SR 3/US 41/Northside Parkway/ Cobb Parkway

**Project Number: BHFST-0001-05 (024), P.I. No.: 720125
and CSSTP-0009-00 (410), P.I. No.: 0009410
Fulton/Cobb Counties**

Value Engineering Study Report

August 2009

ALTERNATIVE
 B-1
 ORIGINAL DESIGN
 SHEET 2 OF 5

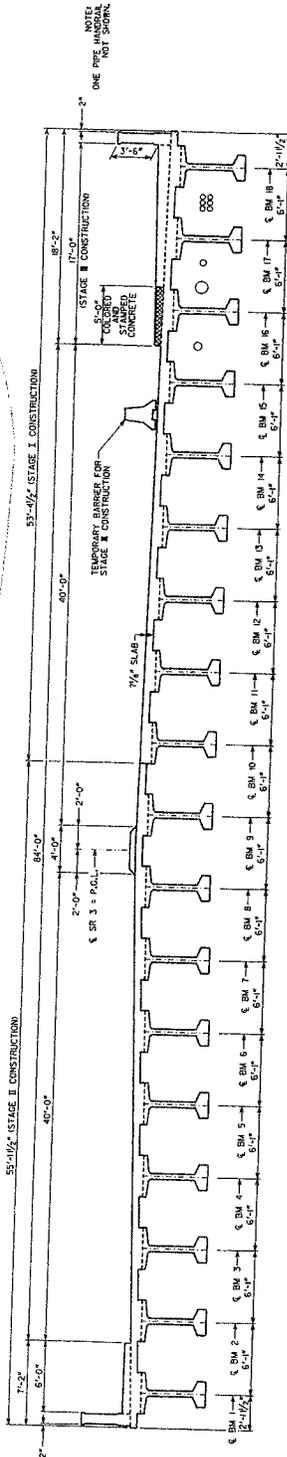
The original design uses 65-in-deep Bulb-T beams. There are 18 beams in the original design while only 14 are required for the alternative design. In order to provide the required 14 ft 6 in clearance distance over the NRA Access road that goes under the bridge, it will be necessary to raise the grade of the approaches about 3 in in the vicinity of the bridge. The cost used in the estimate for the 65 in beams is the same as the cost of 63 in beams in the GDOT Item Mean Summary, so this cost was factored up to account for the additional concrete in the 65 in beam (see calculations page).

DESCRIPTION: **REDUCE STAMPED CONCRETE WIDTH ON MULTI-USE PATH FROM 5 FT TO 3 FT; REDUCE THE BRIDGE WIDTH BY THE SAME 2 FT** SHEET NO. **1 of 4**

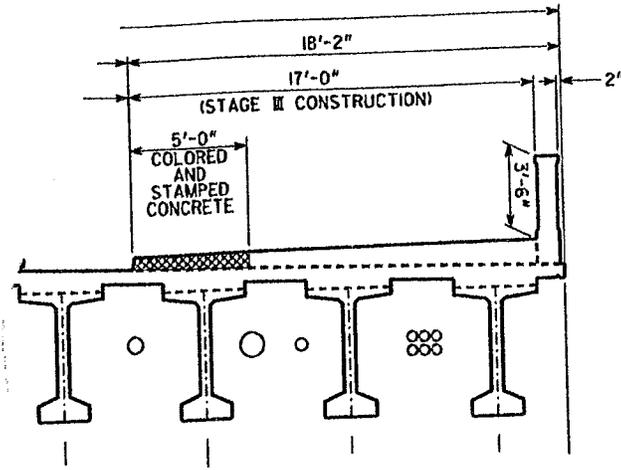
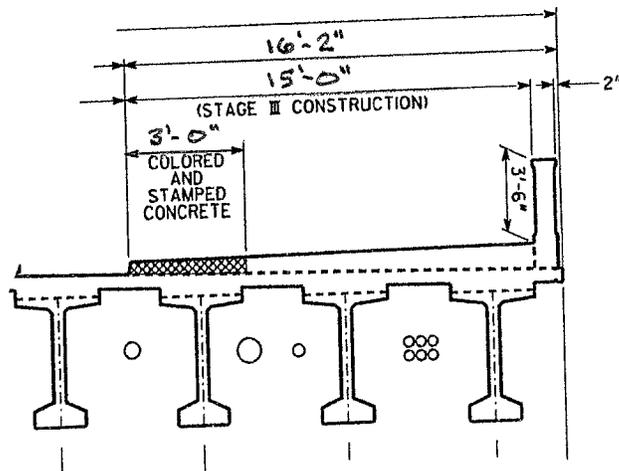
Provide a 2 ft gutter and 3 ft of stamped, colored concrete between the edge of travel way and the multi-use path. Reduce the overall bridge width by 2 ft.

ADA requirements call for 5 ft (desirable) between a multi-use path and the edge of a travel way. The original design provides 7 ft. The alternative design provides 5 ft to reduce bridge costs.

DESCRIPTION: **DELETE THE CONCRETE TRAFFIC BARRIER IN FRONT OF THE MECHANICALLY STABILIZED EMBANKMENT WALLS** SHEET NO.: **1 of 7**

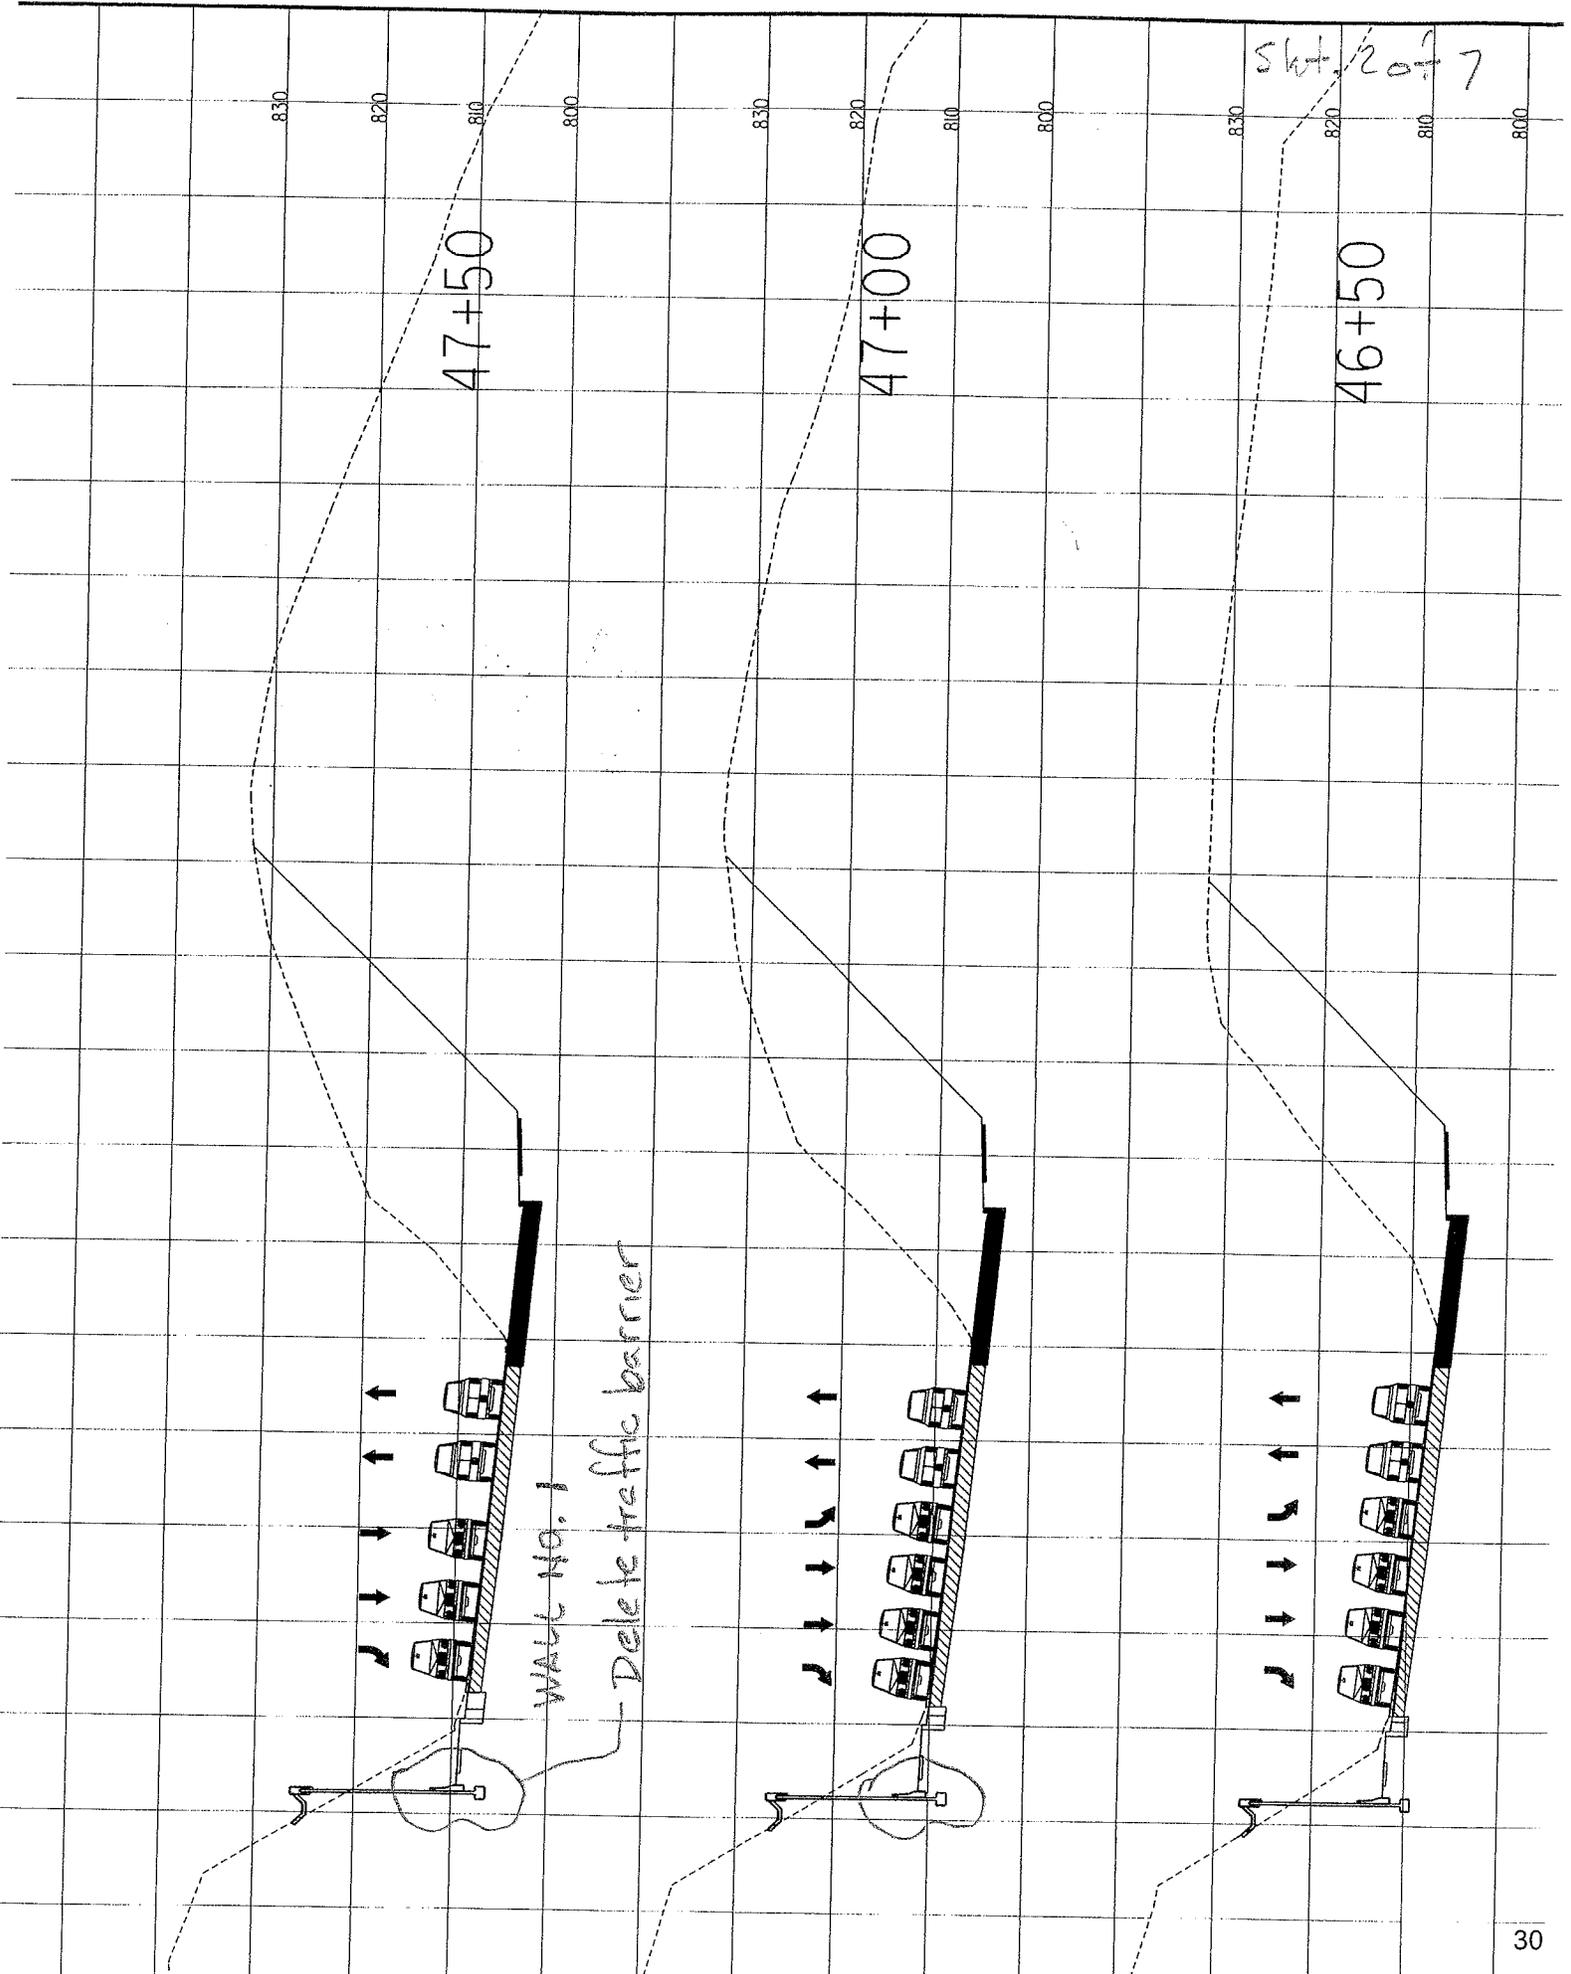
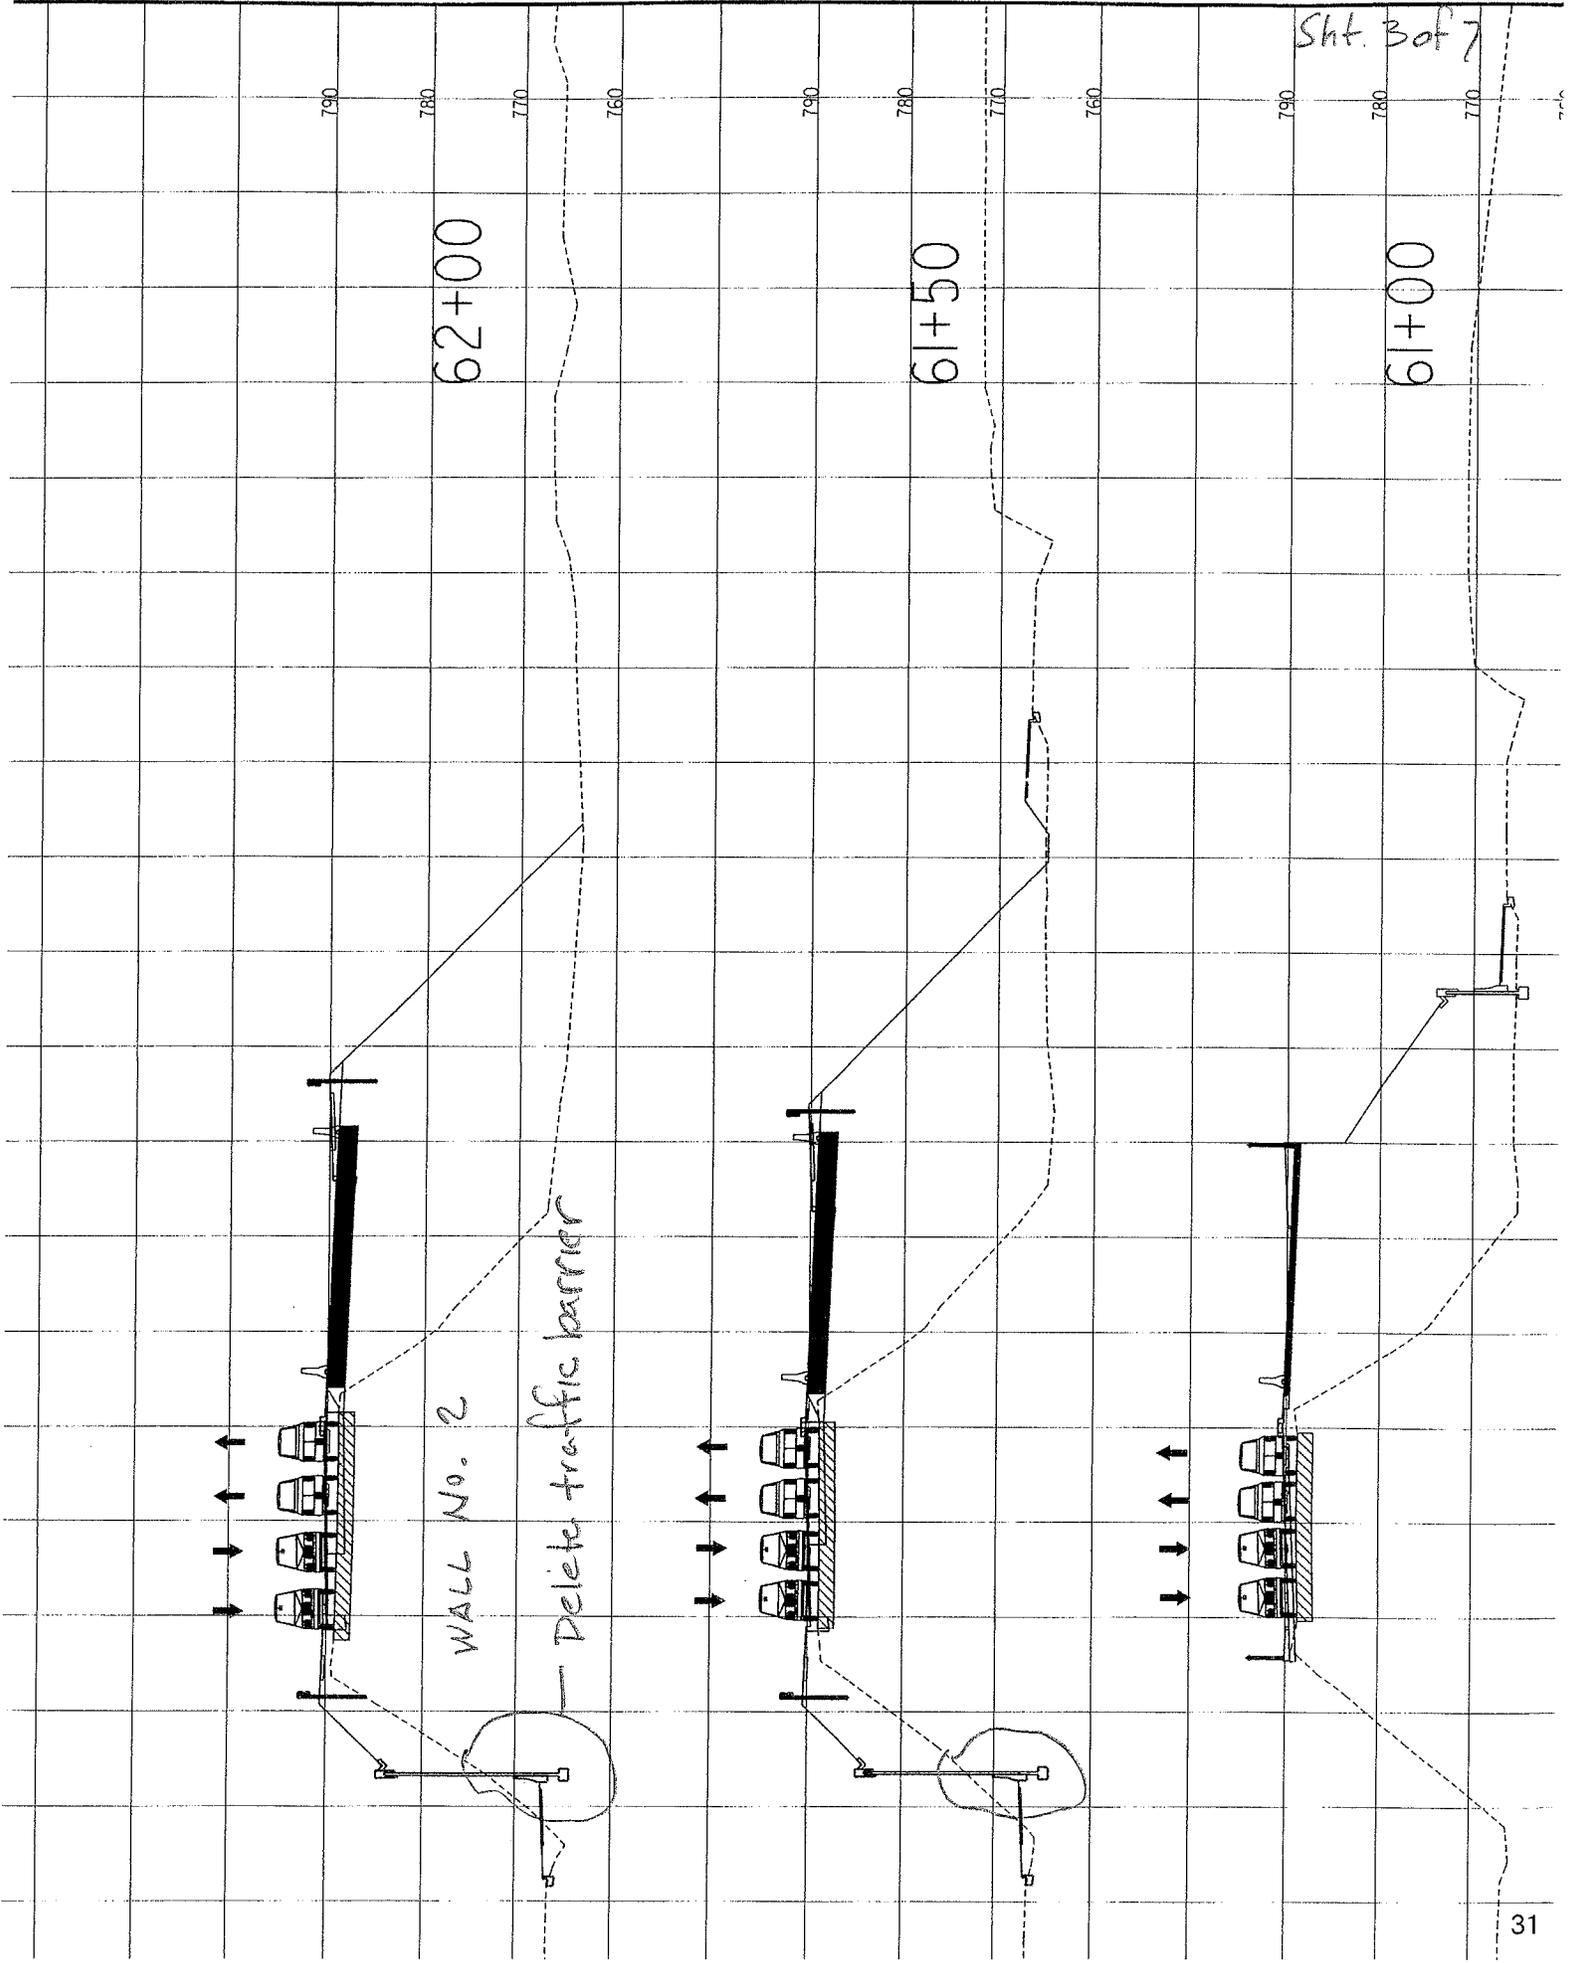
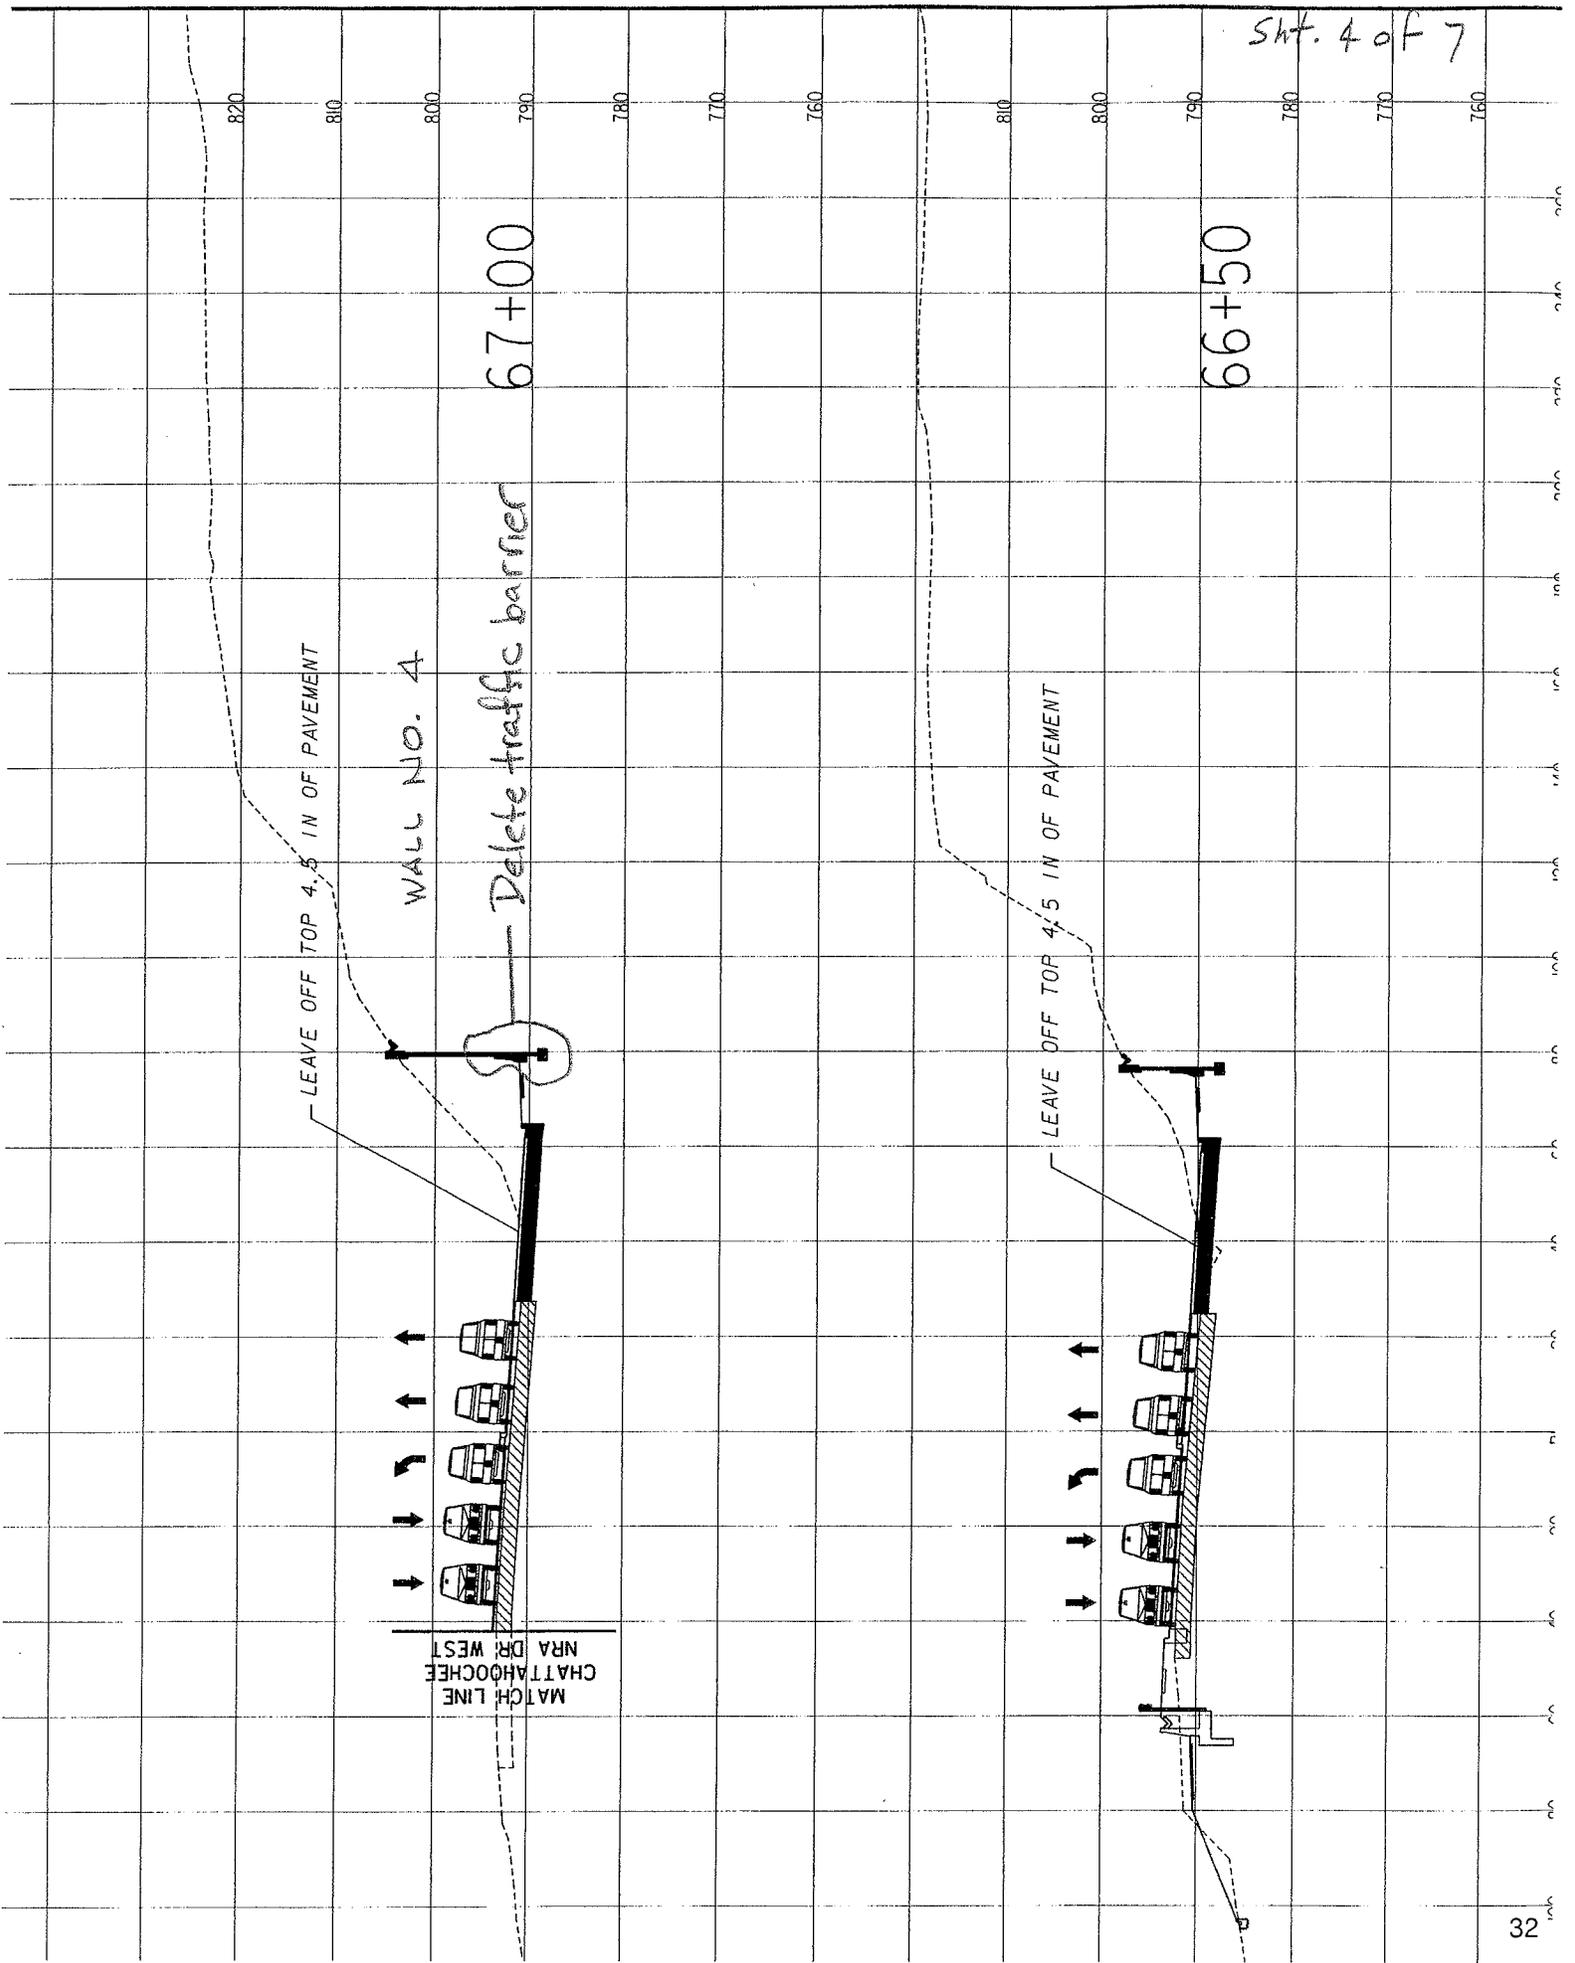
Delete these barriers.

These barriers are being installed to protect a mechanically stabilized embankment wall that is set back from the road about 16 ft. There is a curb at the edge of the roadway and a 16 ft clear zone that will keep most vehicles from getting to the wall. The extra wall protection adds to the project's cost while providing little functionality.

Delete traffic barrier

Delete traffic barrier

Delete traffic barrier
